May 30, 2017

WSP Reference No: 171-05352-00

Subject: Geotechnical Review of Large Stockpile
Stokes Pit – 19525 20th Ave., 19648 24th Ave., 19500 26th Ave., 2990 194th St.,
Surrey, BC

FIGURE 2

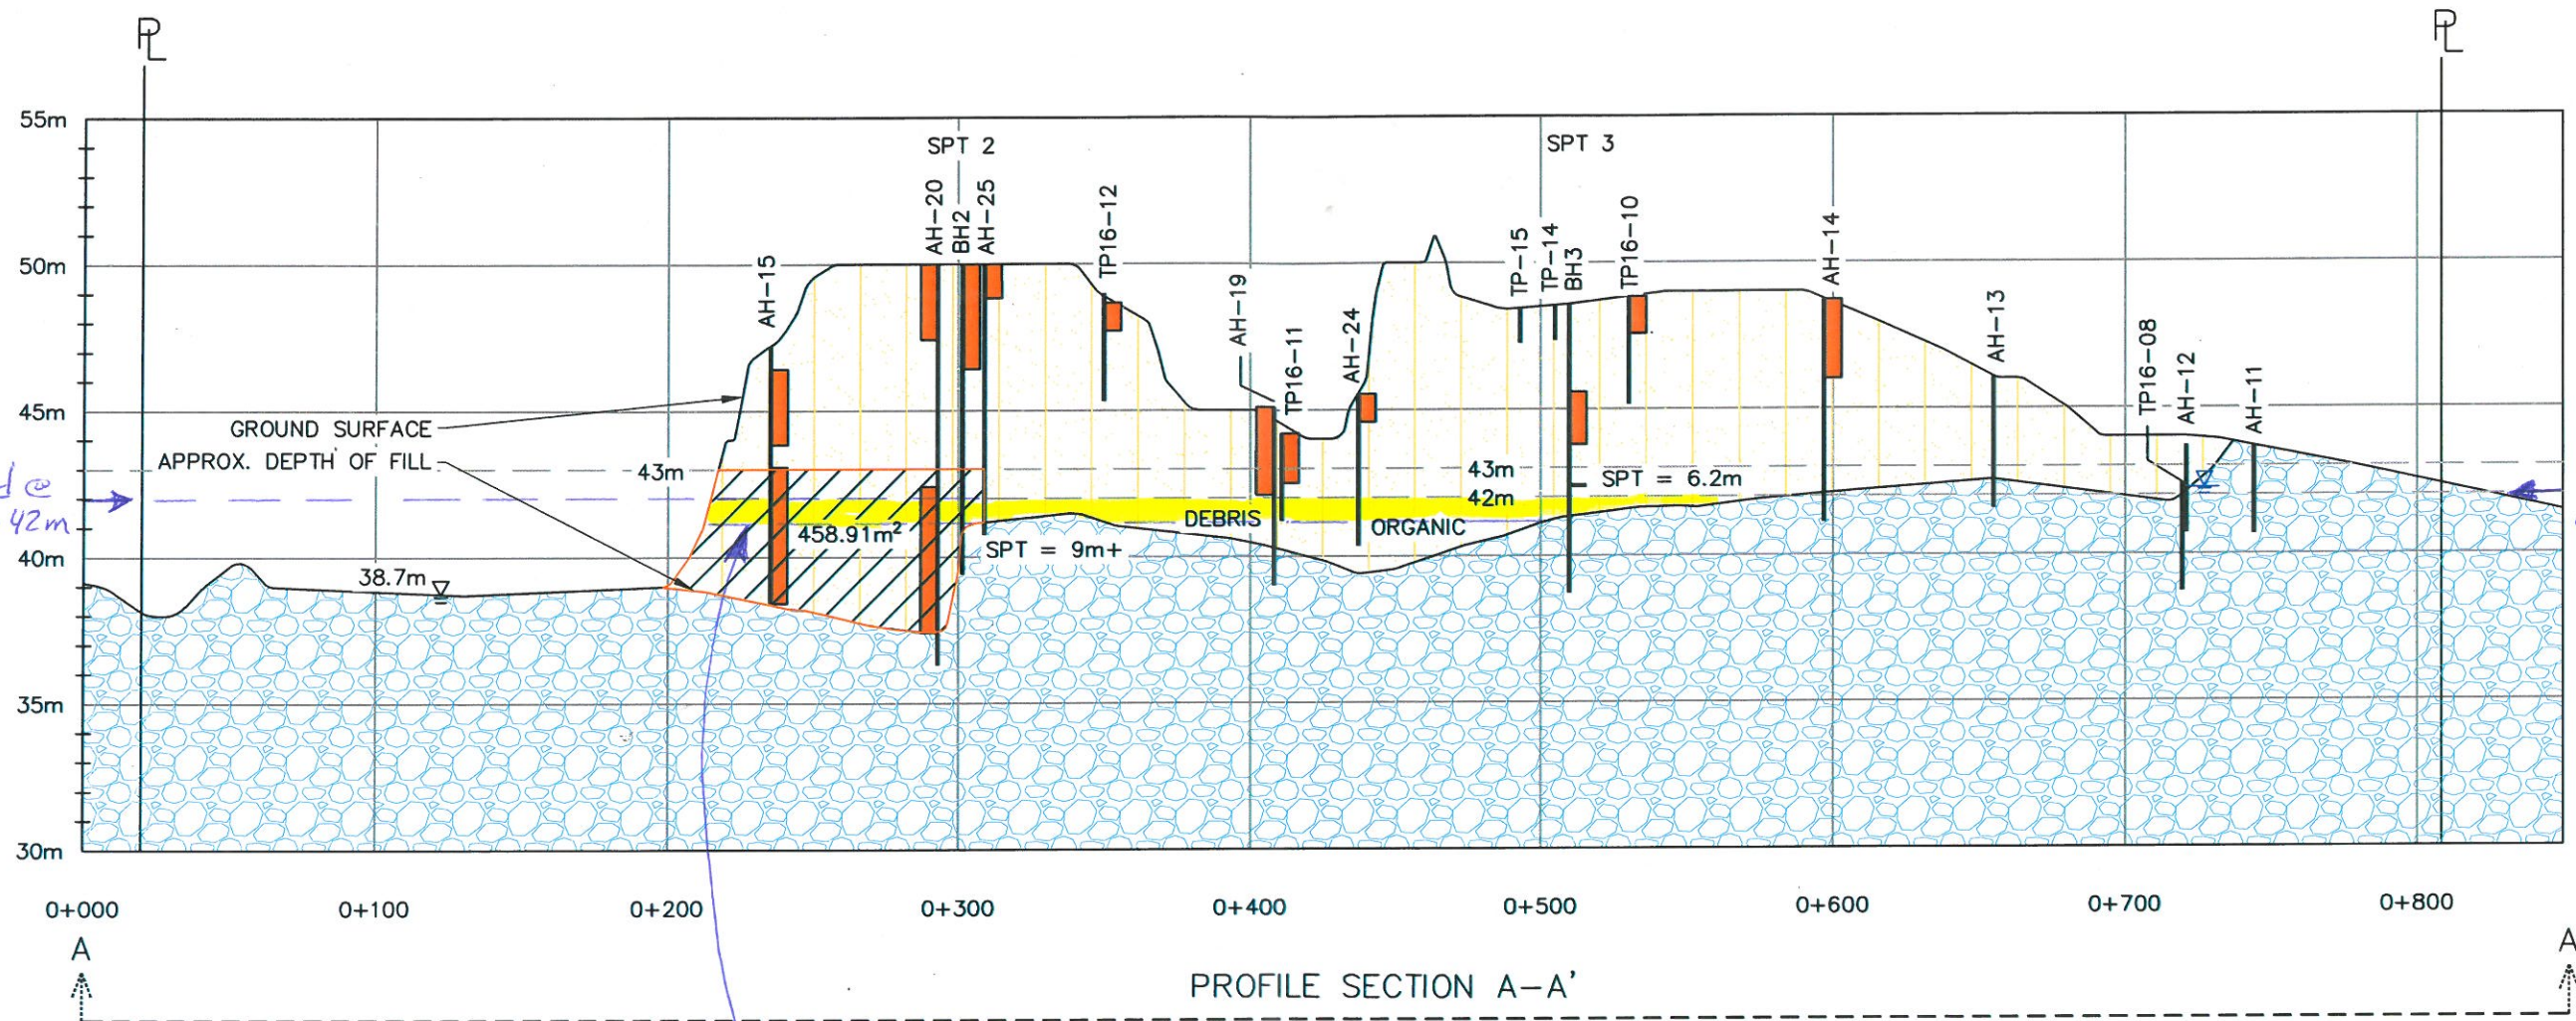
Based on the finished asphalt being at approximately Elev. 42 m and the underside of the pavement section at approximately Elev. 41 m, only about 1 to 2 m of fill would remain in place. Refer to the attached "marked-up" AEE Figures 2 to 5. Based on our review of the test hole logs, this 1 to 2 m of fill generally consists of silt and sand with occasional debris and organics, which would be a relatively weak subgrade, but settlement should not be much more than what would normally be expected for roads and pavement areas since these soils have been preloaded with the stockpile of fill. There will be some areas, such as at test hole AH-18, where organic silt and peat fill will need to be subexcavated below the pavement section.

1m thick
pavement section.
